COMMITTEE OF THE WHOLE – SEPTEMBER 19, 2005

YONGE STREET CORRIDOR PUBLIC TRANSIT IMPROVEMENTS INDIVIDUAL ENVIRONMENTAL ASSESSMENT – REGION OF YORK COMMENTS TO THE MINISTRY OF THE ENVIRONMENT EA FILE NO. MU-1033

10-7
FIGURE

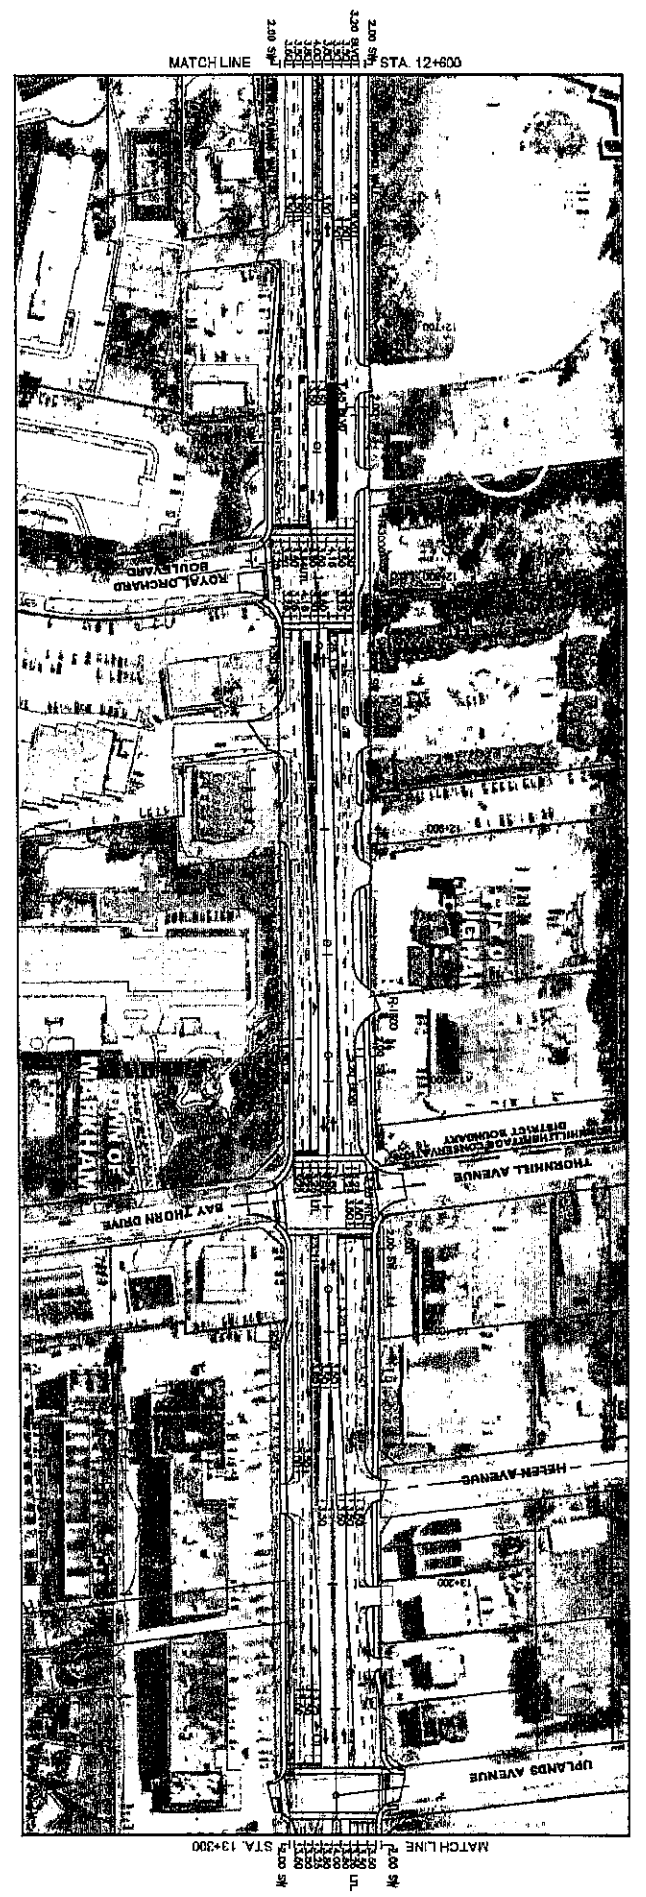
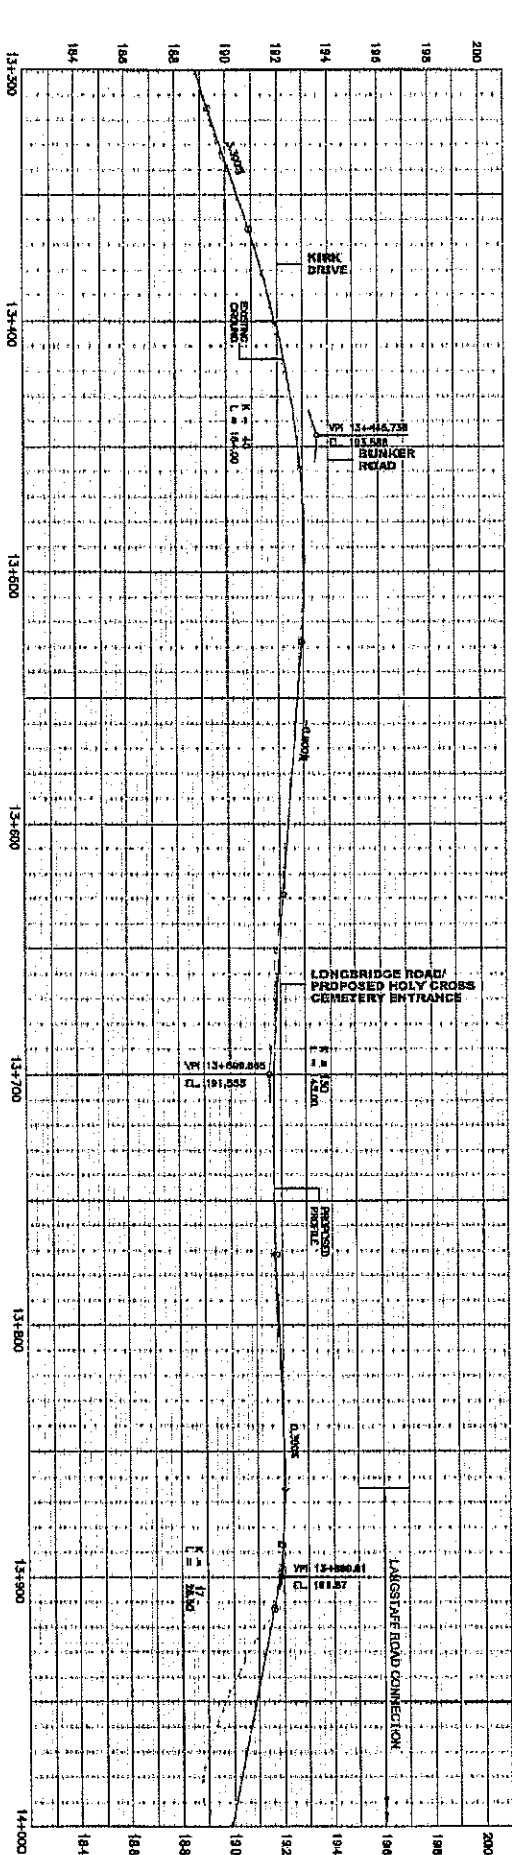
From Royal Orchard to the Richmond Hill Intermodal Terminal the road configuration varies to accommodate local conditions, as shown in Attachments 2f and 2g. From Royal Orchard Boulevard to Helen Avenue the centre landscaped median has been eliminated and the boulevard widths continue to be variable. The travel lanes have also been reduced to 3.25 m in width. The Bunker Road to Langstaff Road section forgoes the median landscaping strip, with a variable boulevard width between Bunker and Longbridge Roads. Beyond Longbridge Road the boulevards return to a standard 5.2 m width.

10-8
FIGURE

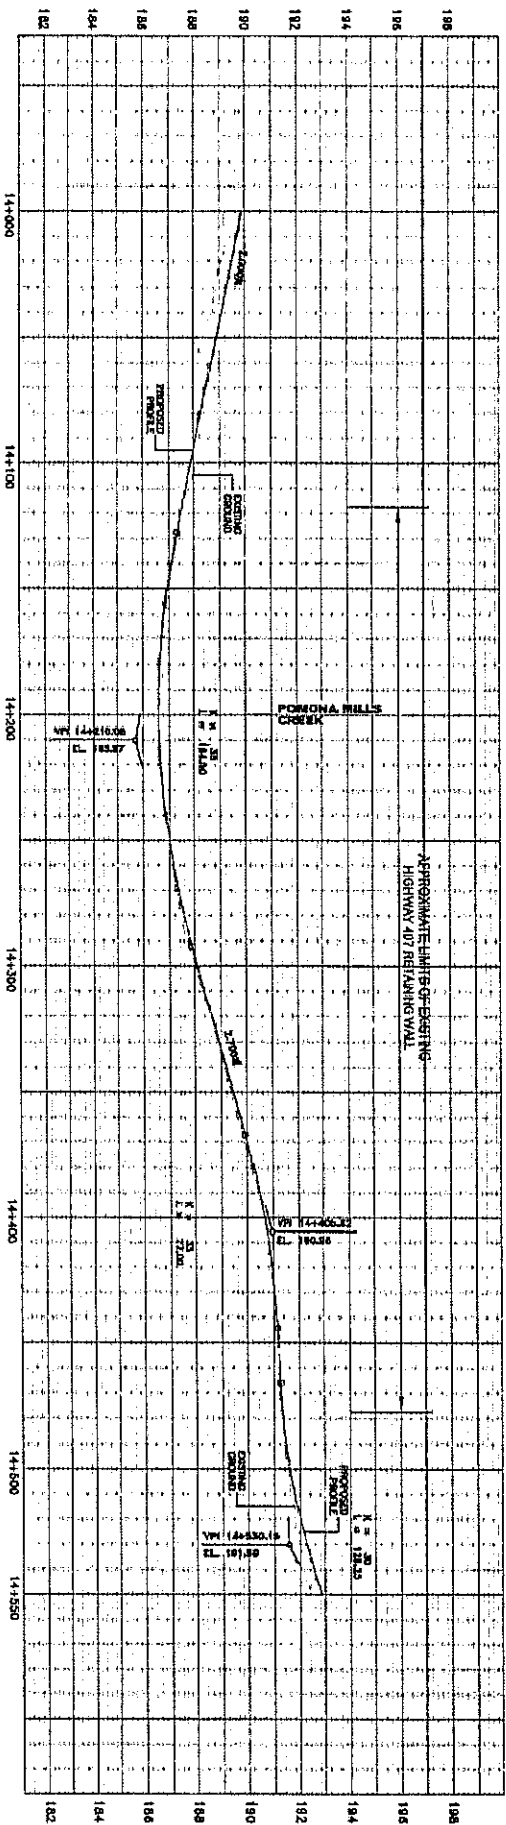
Access to and from the Richmond Hill Intermodal Terminal (Attachments 2h and 2i) is obtained from Yonge Street, by way of Langstaff Road. The transitway, rather than crossing Highways 7 and 407 on Yonge Street, proceeds to the east at Langstaff Road and follows the path of the road allowance to the CN Rail Bala subdivision underpass, where it heads north, paralleling the rail line into the intermodal facility.
